N9917A-01

S E R V I C E N O T E

N9917A - FieldFox Handheld Analyzer

FieldFox instruments with the serial numbers listed on the following page are being returned to Agilent factory so the RF board can be upgraded for reliability enhancement, due to possible oscillation by the voltage regulator on the RF board.

Figure 1: No sidebands issue

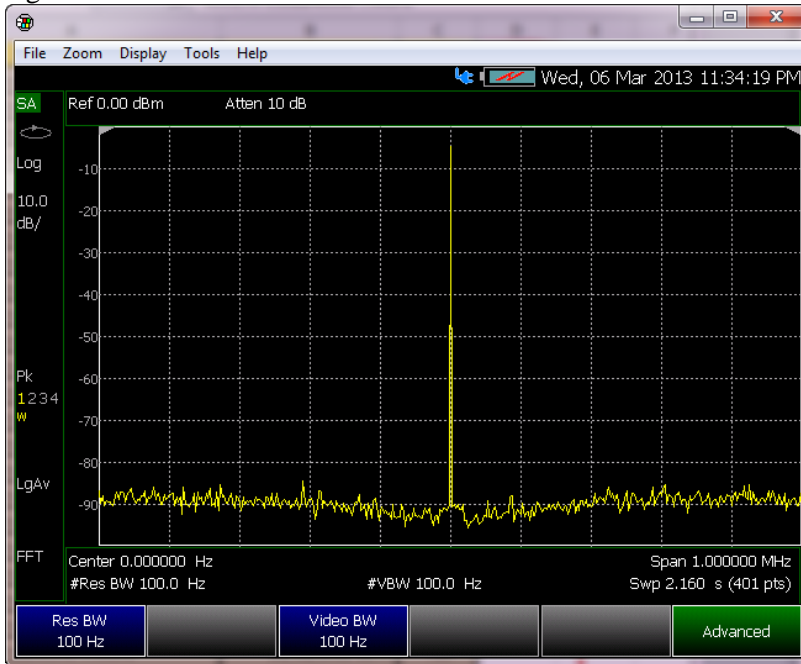
RF board earlier than Rev 7 may have sidebands issue due to oscillation by the voltage regulator. After it is fixed by replacing a new inductor, the RF board revision header will be updated to reflect the change.

Figure 1 shows a good RF signal, and Figure 2 shows FieldFox with sidebands issue.

Affected FieldFox are required to send back to Agilent factory for RF board reliability enhancement. The RF board revision header will be updated to reflect the change. Test and Adjustment shall be done before shipping back to customer.

Figure 2: Sidebands issue between 112 - 116 kHz

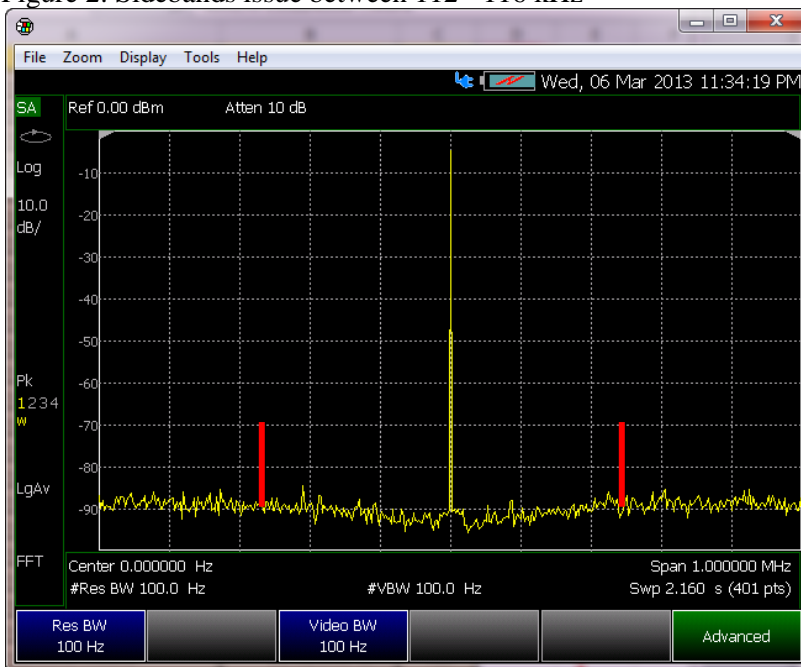
Follow below procedure to check if the FieldFox may have sidebands issue between 112 kHz to 116 kHz.

1. Press Mode, select SA
2. Press Freq/Dist, set center frequency as 0 Hz, Span: 1 MHz.
3. Press BW, set Res BW: 100Hz, and Video BW: 100 Hz
